REMARKS

Attorney Docket No. L8612.04117

IN THE DRAWINGS

FIG. 1
PRIOR ART

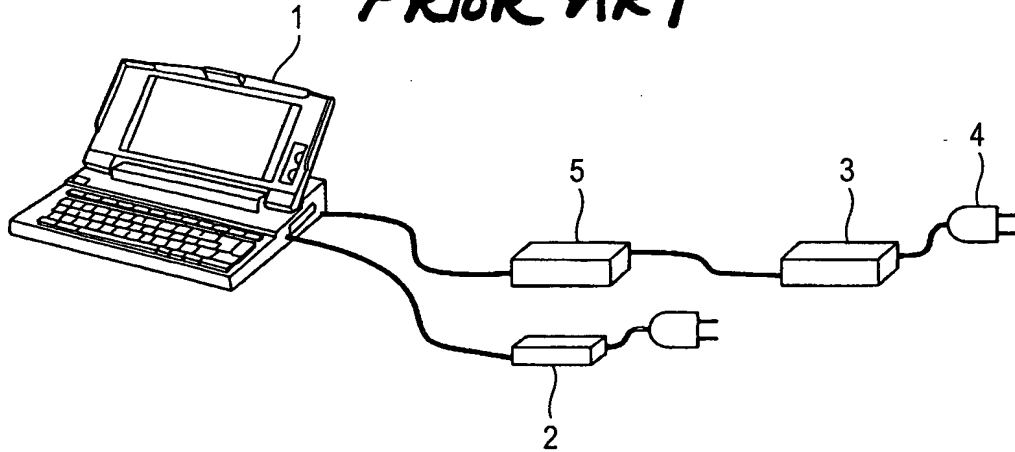
As required in the Quayle Action, proposed changes to Fig. 1 are submitted herewith, with a Letter to the Official Draftsman, labeling Fig. 1 as "Prior Art." A sheet showing the changes in red ink and a replacement sheet are attached.

A proposed change to Fig. 1 is submitted herewith with a Letter to the Official Draftsman.
